Naco Ground Storage Tank Rehabilitation Project
SAWS Solicitation No. B-19-015
Job No. 17-0113

ADDENDUM 3
December 13, 2019

DWG FILE: TIME: EPT DATE:

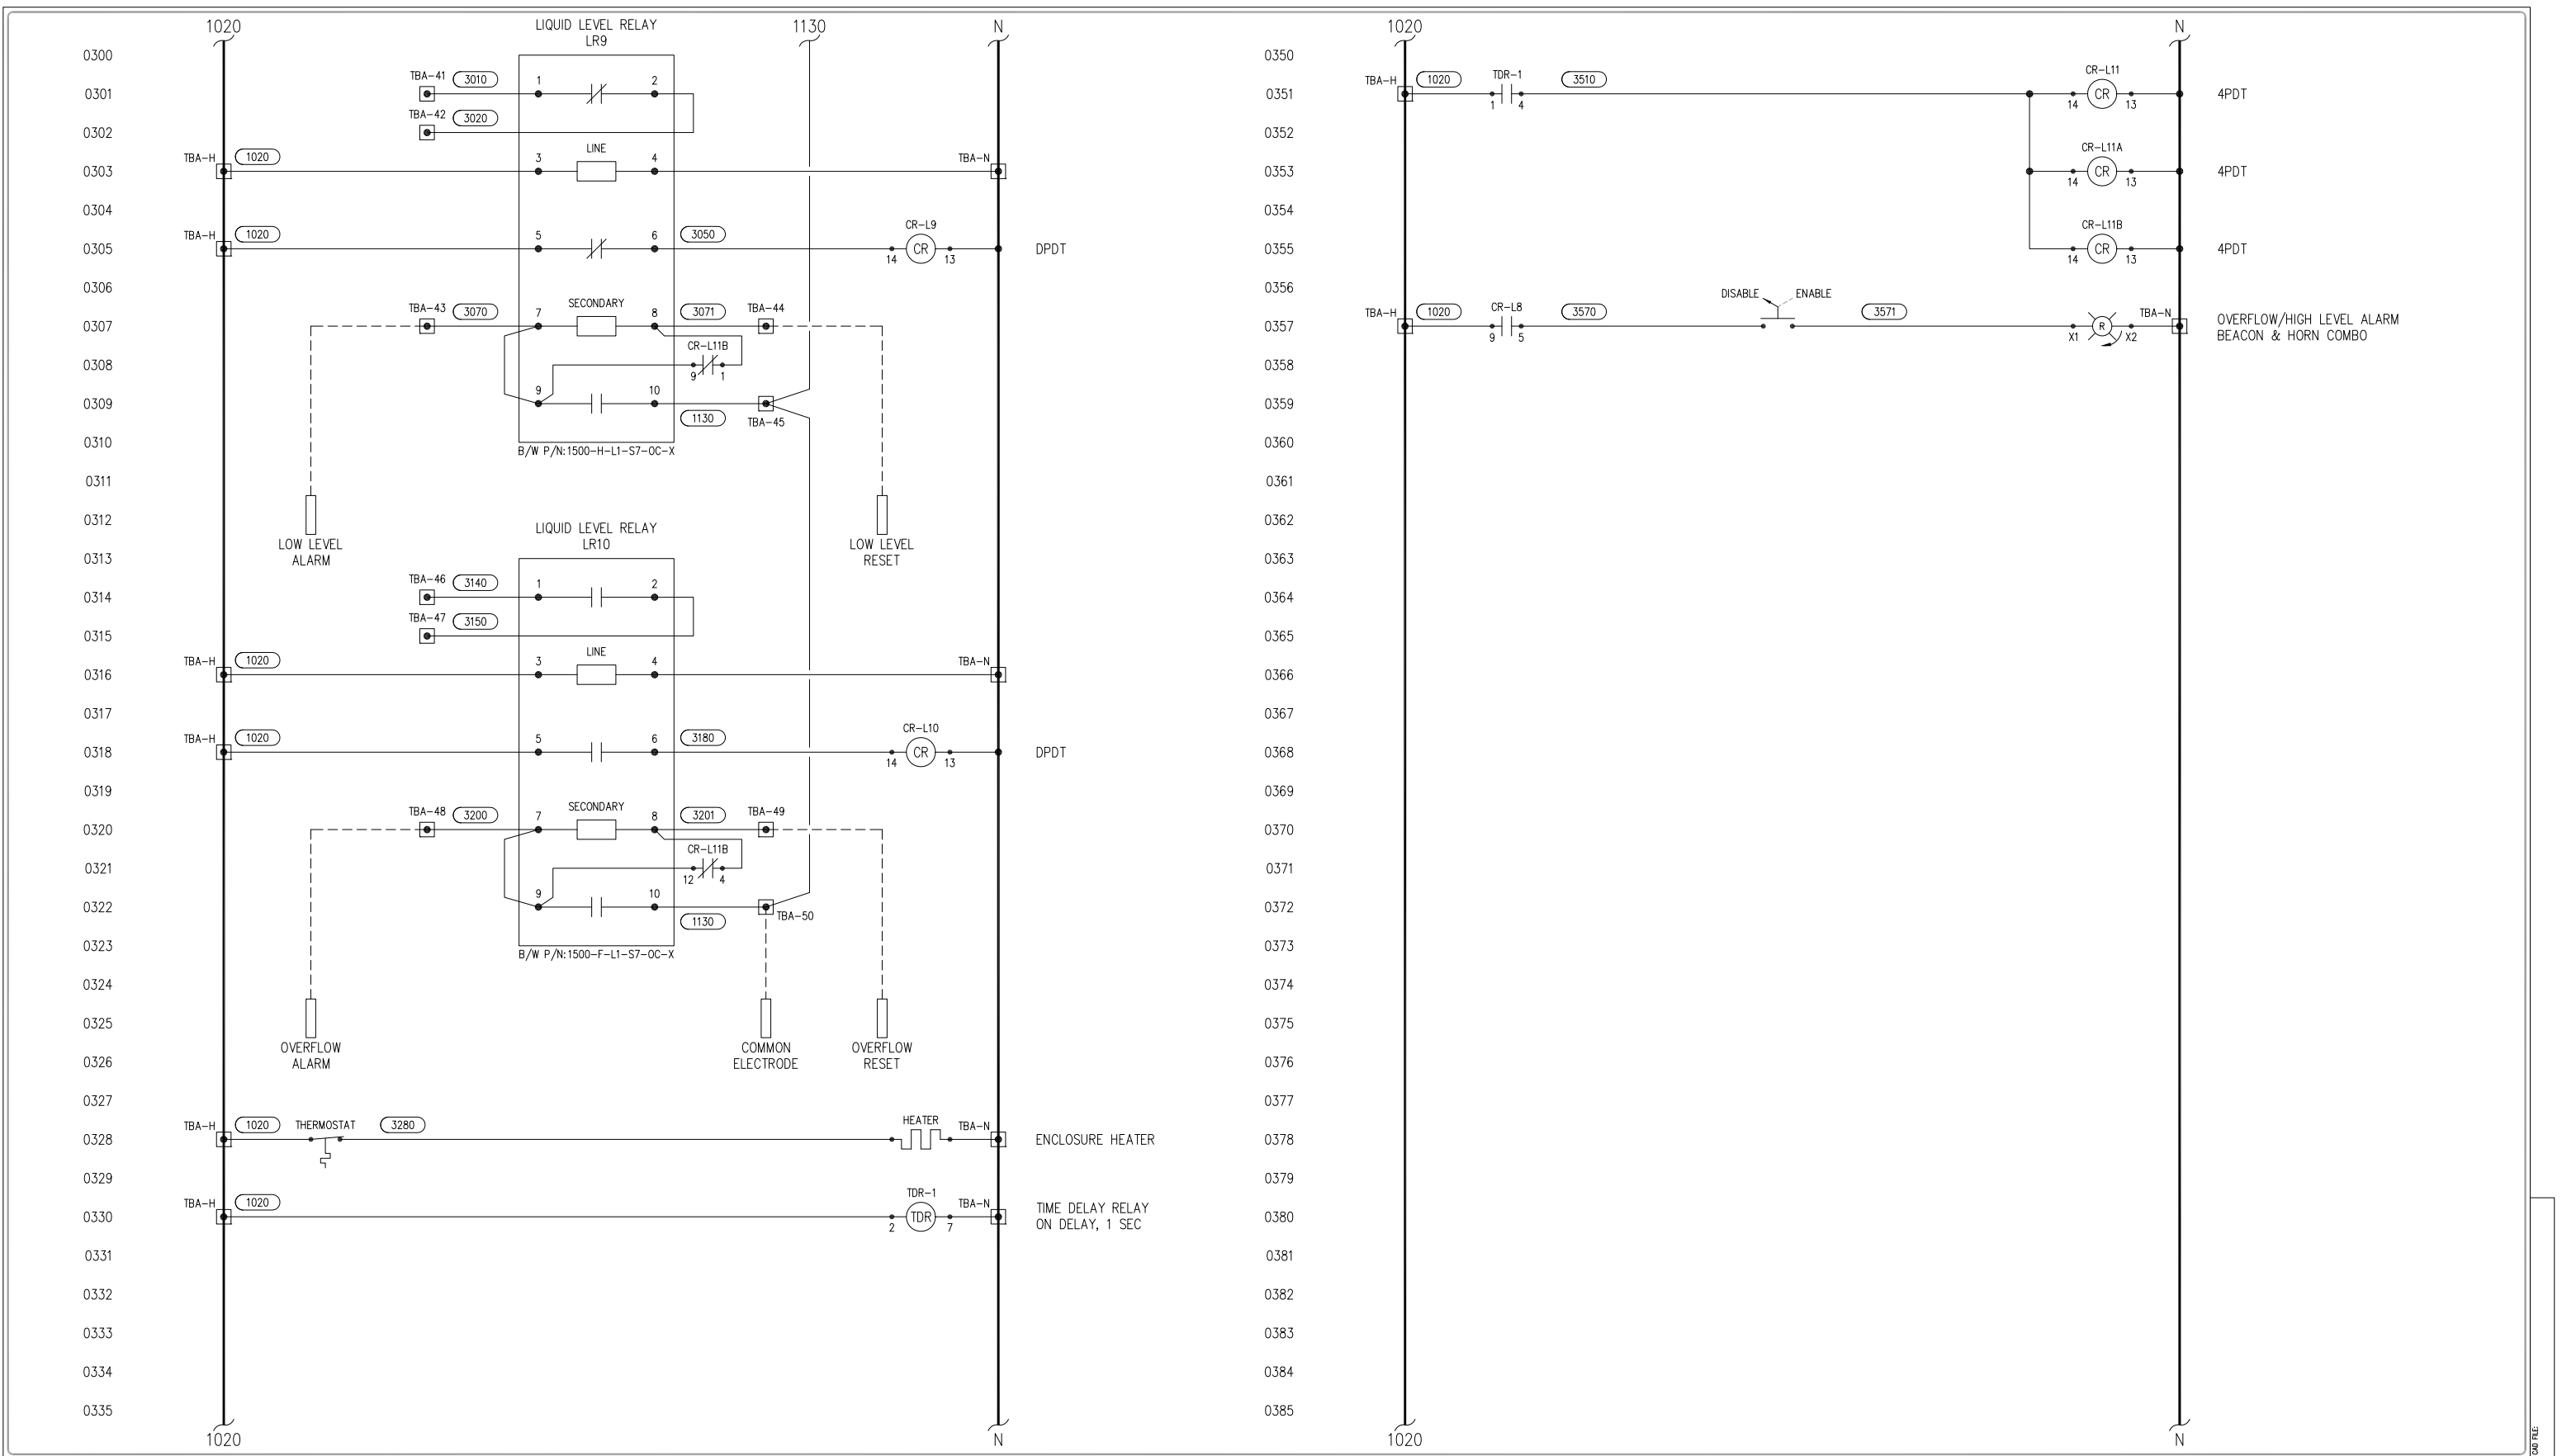
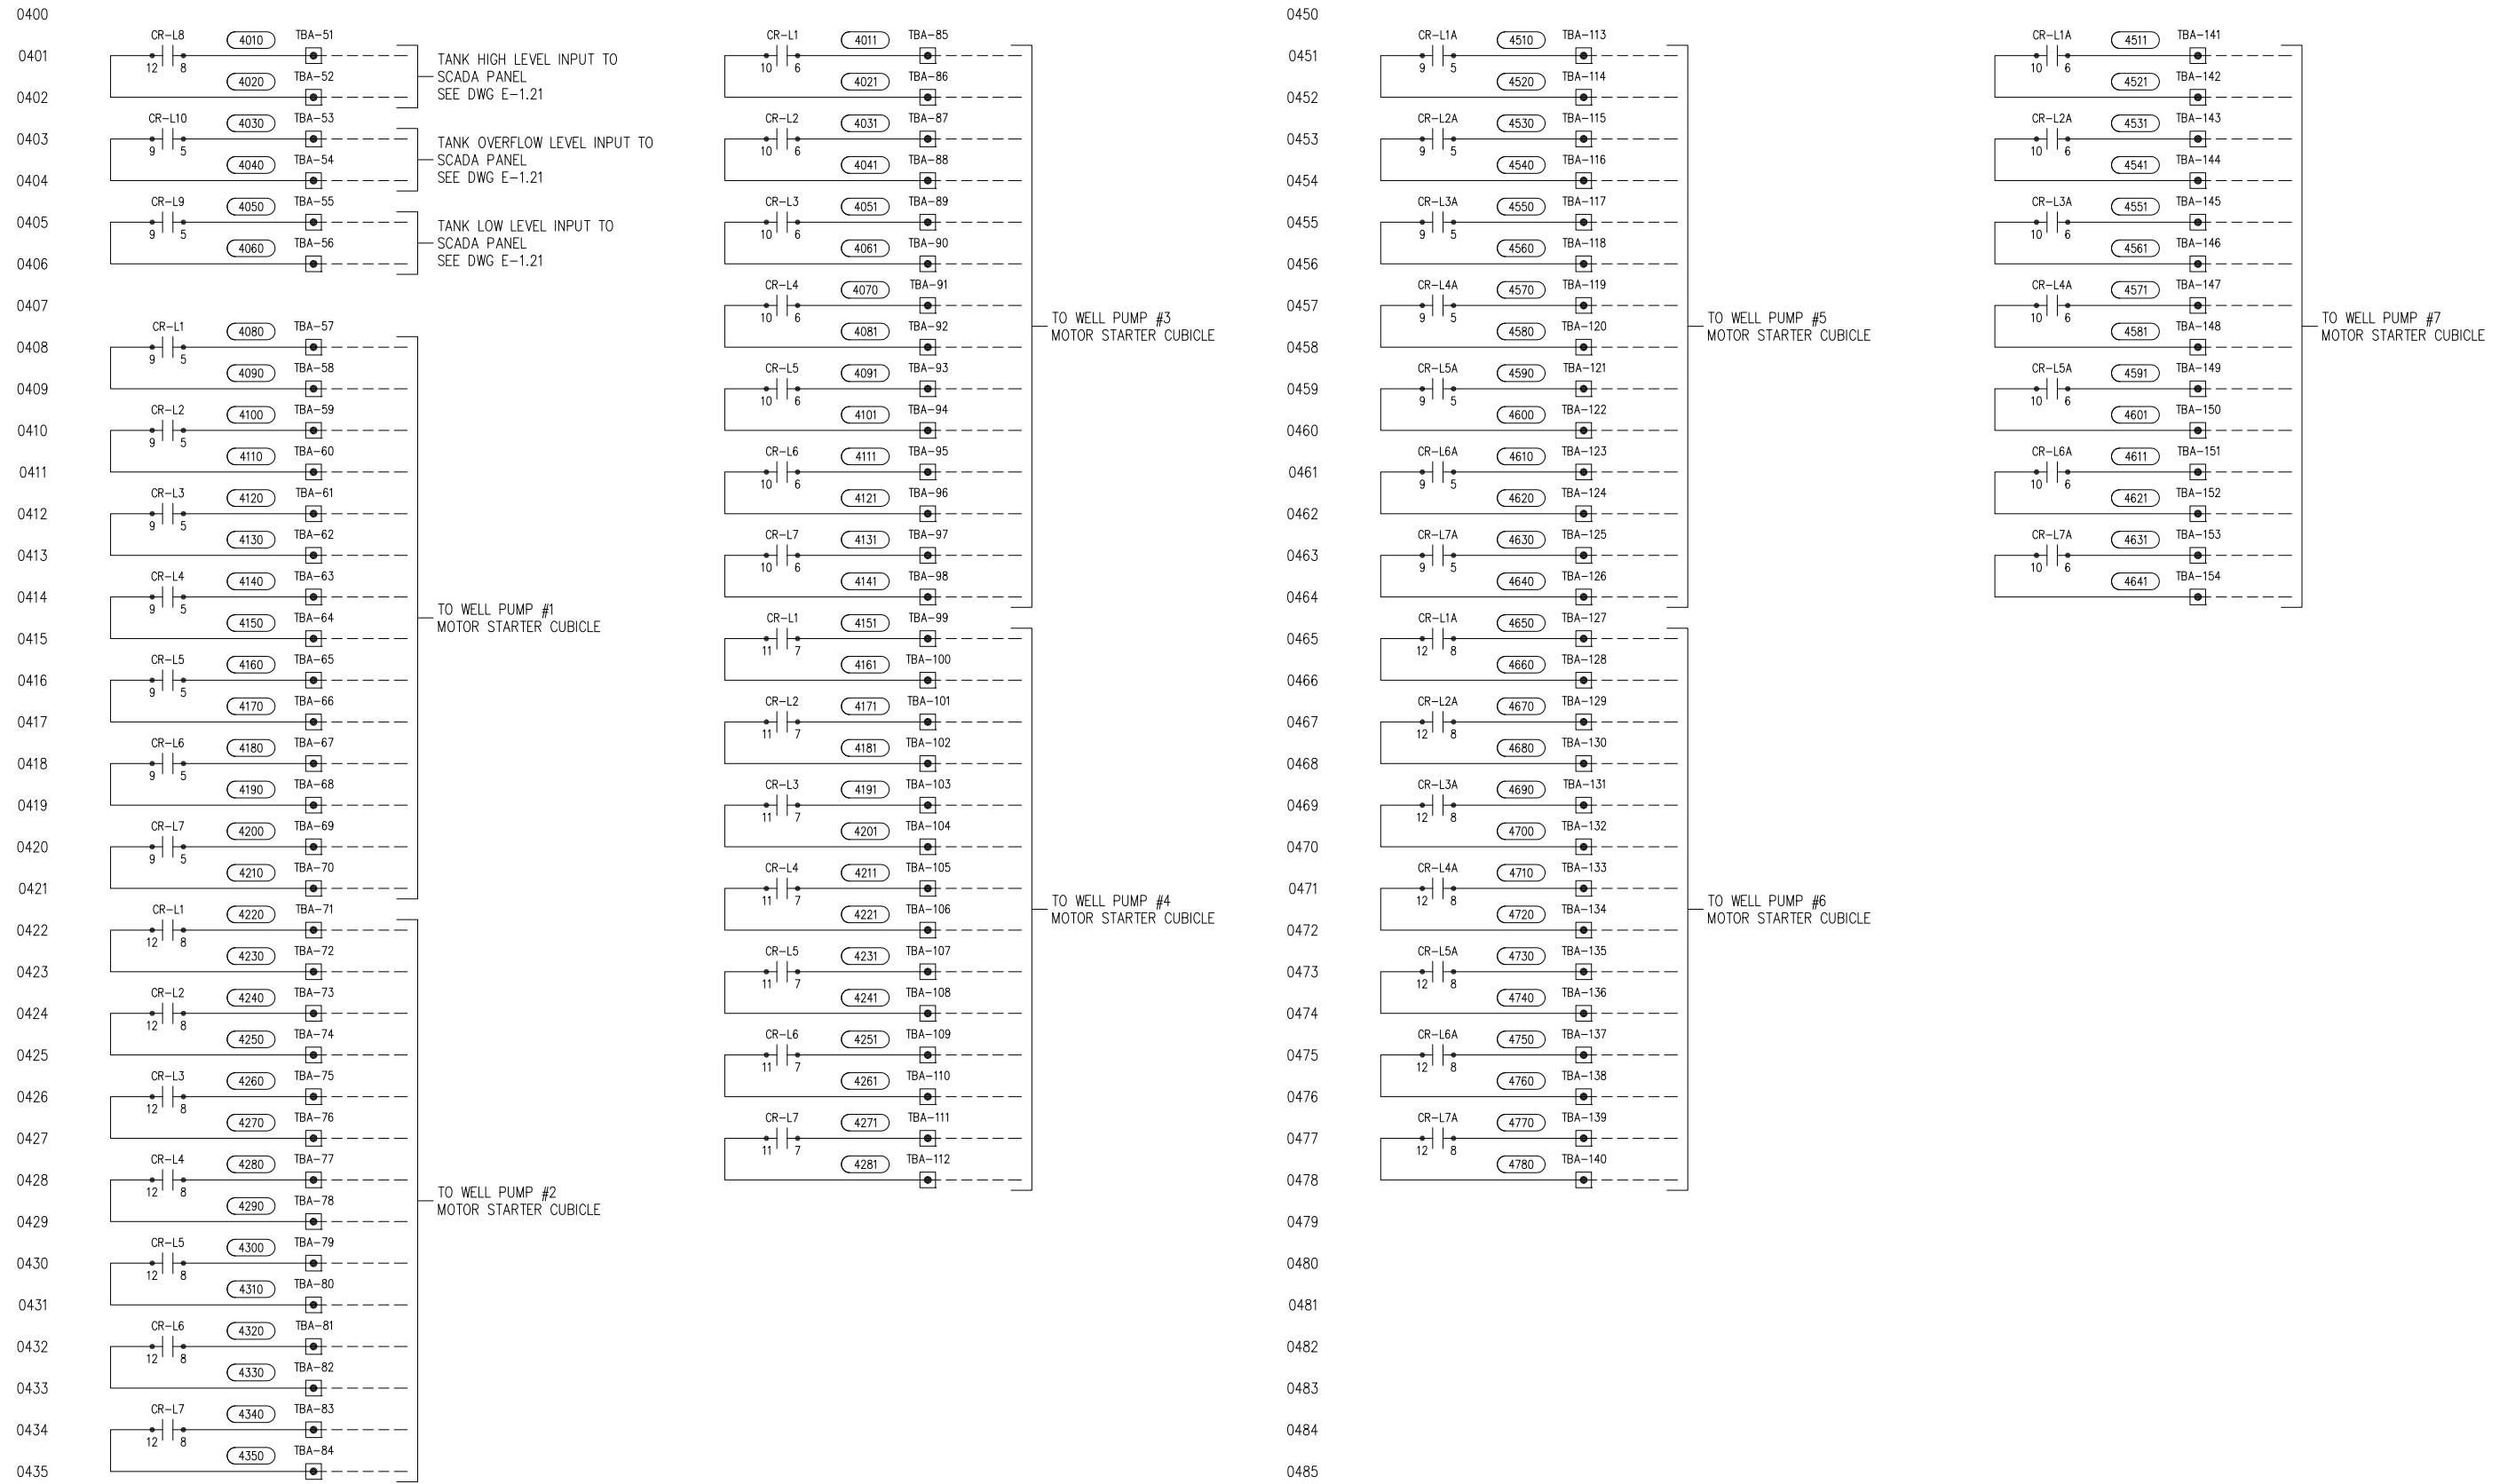
1. **Question:** Sheet E4 Keyed Note 3 states “THE NEW ELECTRODE PROBES TO BE CONNECTED TO EXISTING RELAYS IN LEVEL CONTROL PANEL. CONTRACTOR SHALL DOCUMENT ALL EXISTING CONNECTIONS AND RE-CONNECT NEW PROBES TO THE SAME TERMINALS.” However, during the site visit, we did not see any probe cables being routed to the level control panel. Please advise.?

Response: The previous contractor had already removed the probes and cable. Attached are the record drawings of this panel which are included in Addendum 3.
